**From:** Teresa Kubo [Kubo.Teresa@epamail.epa.gov]  
**Sent:** Thursday, June 20, 2013 11:14 AM  
**To:** Kubo, Teresa  
**Subject:** Fw: BPA substation

From: Chip Humphrey/R10/USEPA/US  
To: Teresa Kubo/R10/USEPA/US@EPA,  
Date: 01/18/2013 05:00 PM  
Subject: BPA substation

I am getting around to combing through the BPA I-5 corridor reinforcement project. All of the action alternatives propose to utilize part of the Reynolds property for a new substation (the Sundial Substation). In addition, lines and access roads would cross a portion of the site. I have included graphics below, as well as their write up for the Reynolds site. Based on their analysis, they conclude there would be "Low impact there the alternatives cross the Reynolds Metals Superfund Site. EPA and ODEQ consider current health risk acceptable."

**Figure 10-2 Reynolds Metal Company Site**

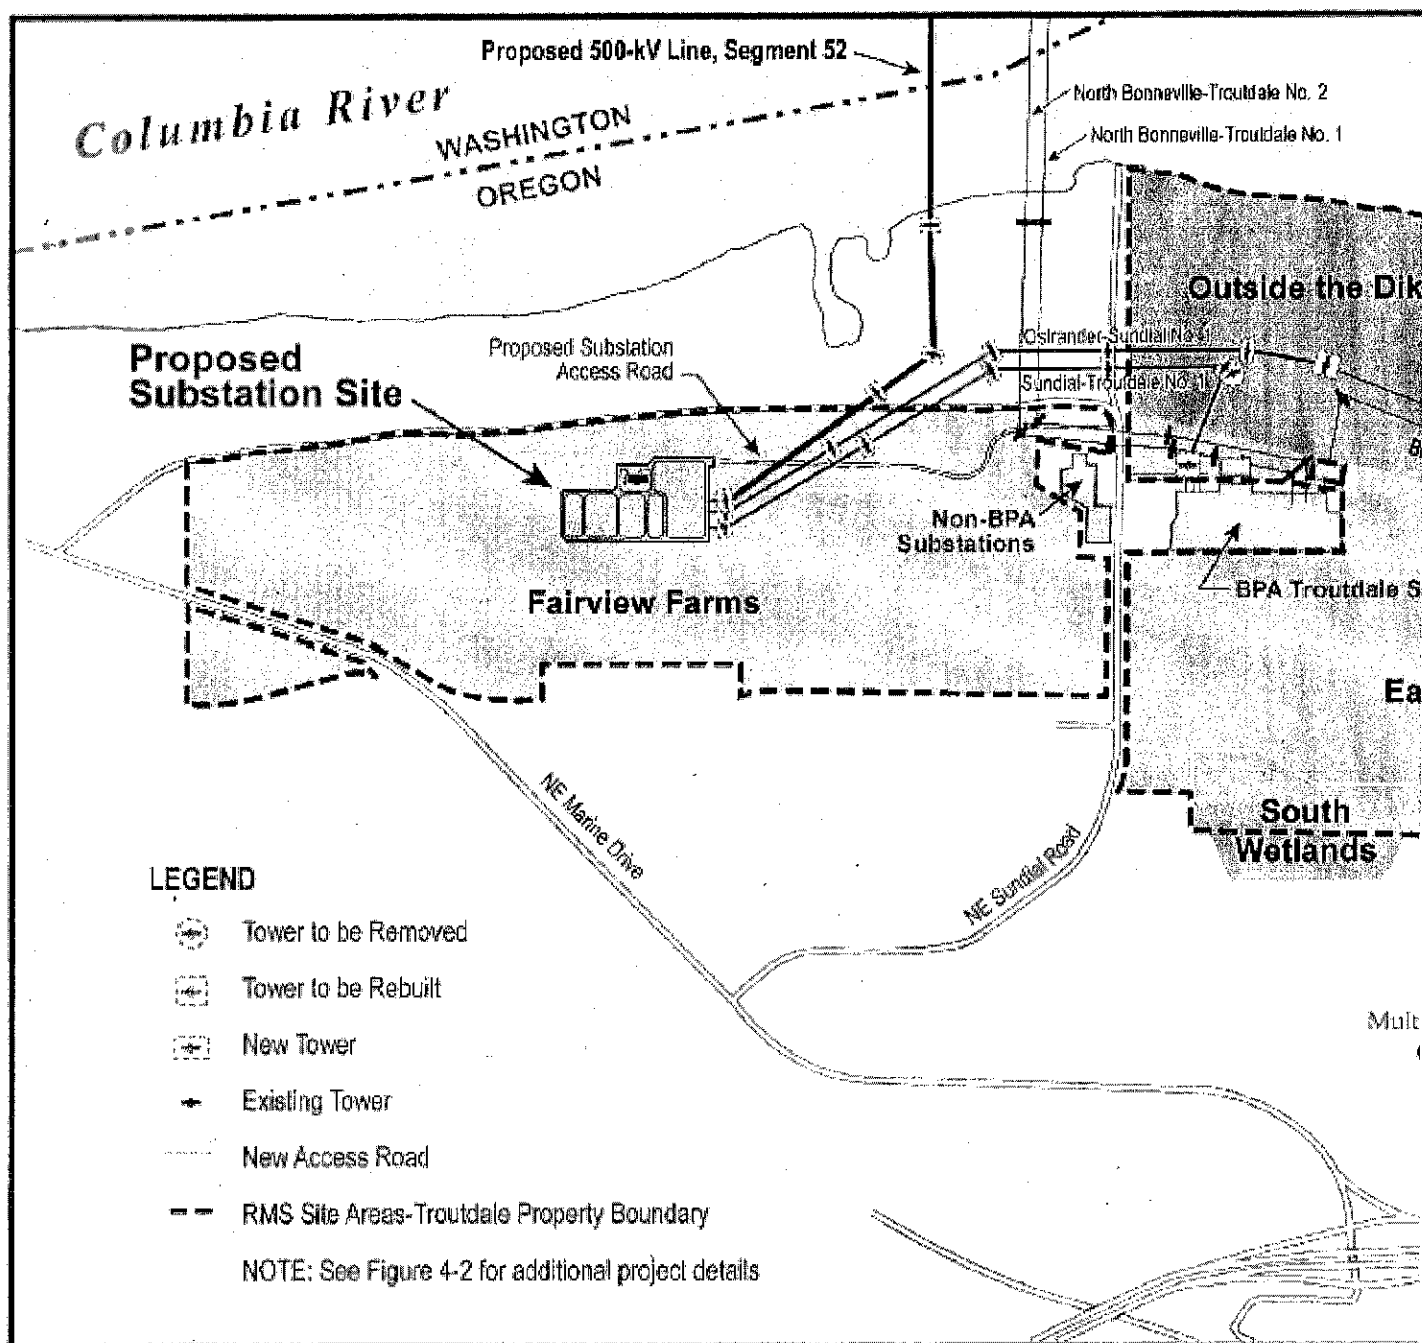
1) Are you satisfied with the way in which the site has been characterized in the analysis?

2) They have not done any additional sampling of the proposed construction site and it is not clear how they will determine the extent to which "special care" should be taken during the excavation and construction process. Do you have any recommended actions they should take prior to construction? If we want them to do any additional sampling we should put that in writing.

We will need to make sure they follow through with their notification to DEQ and EPA prior to construction work and plans will be put in place to address any contamination - this is covered under the substation section but is probably a bigger deal for the tower footings given their proposed locations. Since it looks like this is conceptual at this stage, it's probably better dealt with it when they have firmed up the actual locations for the towers and substation. It generally looks OK right now, but there are definite areas to avoid.

*I think it should acknowledge that habitat restoration was completed in a 21 acres area adjacent to Company Lake (a portion of the Outside the Dike area) as part of a Natural Resource Damage Settlement, and that a permanent preservation easement was put in place to protect the area. The current BPA easement trumps that easement, but I'm not sure if all the activities are limited to BPA's current easement in this area.*

*Based on our previous investigations and site history, we wouldn't expect any significant contamination in the area shown for the proposed substation site.*

Figure 10-2 Reynolds Metal Company Site

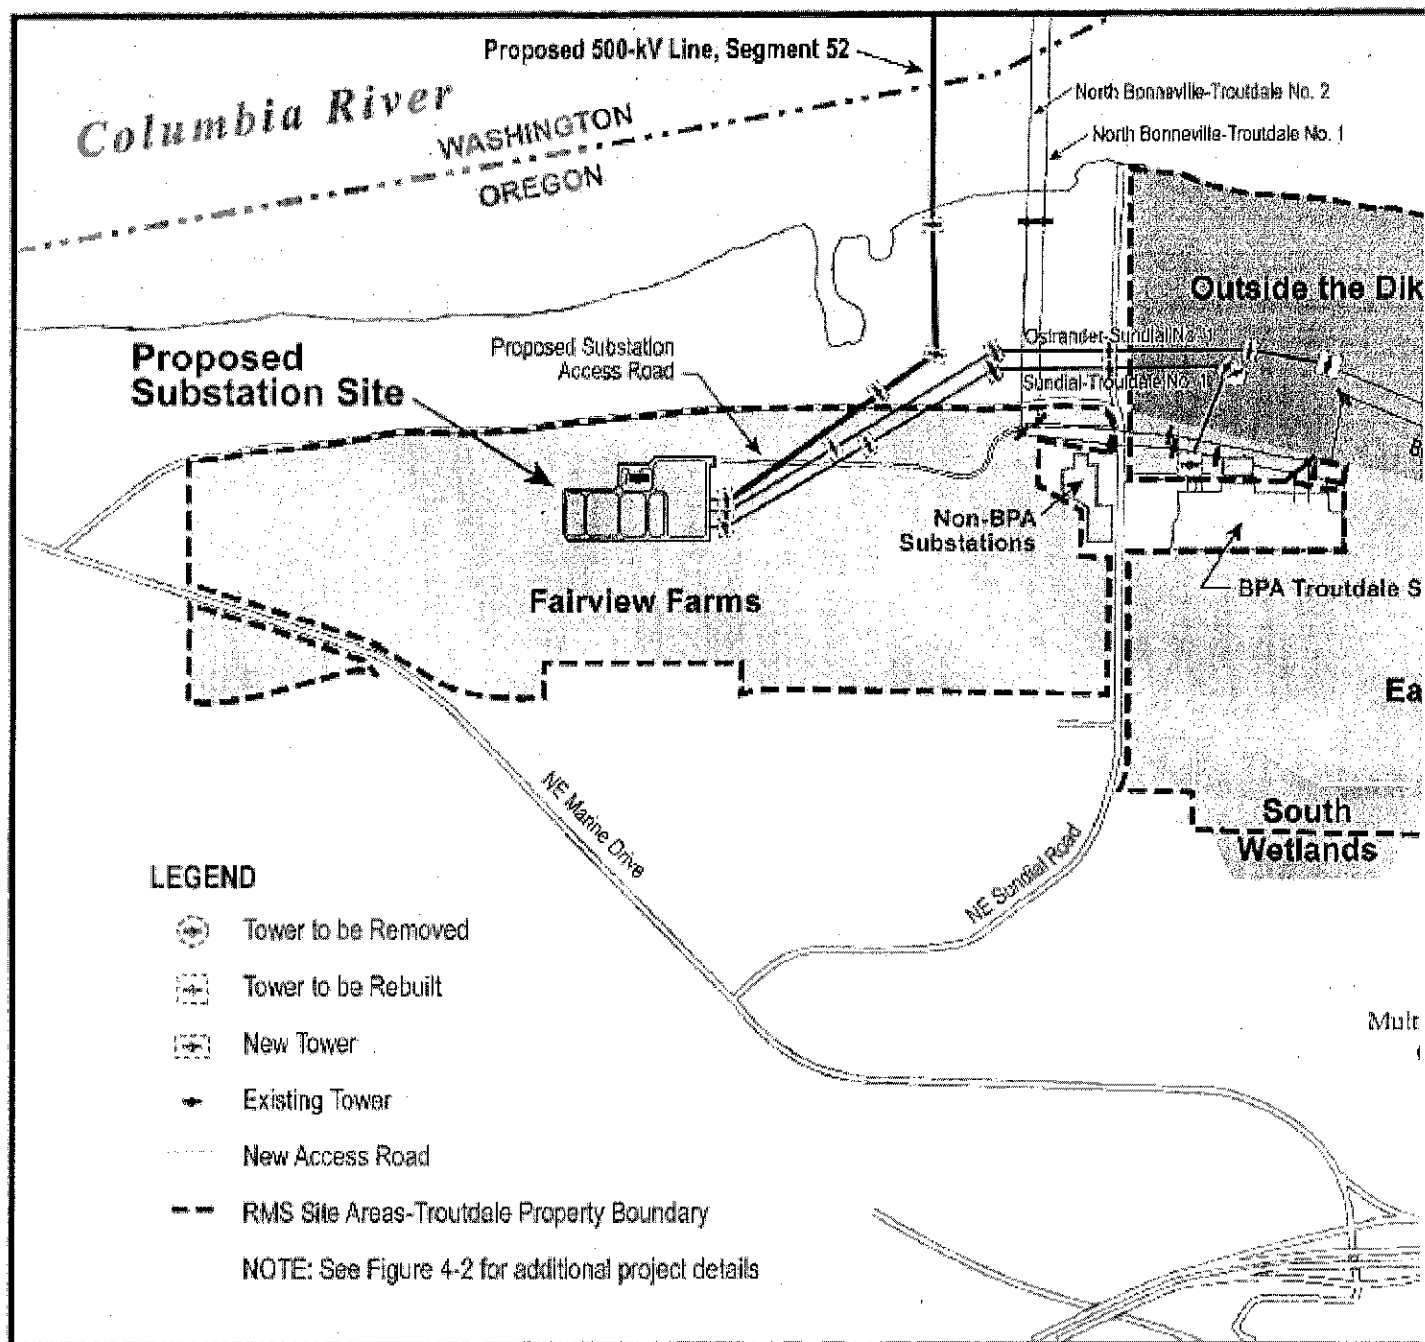
- 1) Are you satisfied with the way in which the site has been characterized in the analysis?
- 2) They have not done any additional sampling of the proposed construction site and it is not clear how they will determine the extent to which "special care" should be taken during the excavation and construction process. Do you have any recommended actions they should take prior to construction? If we want them to do any additional sampling we should put that in writing.
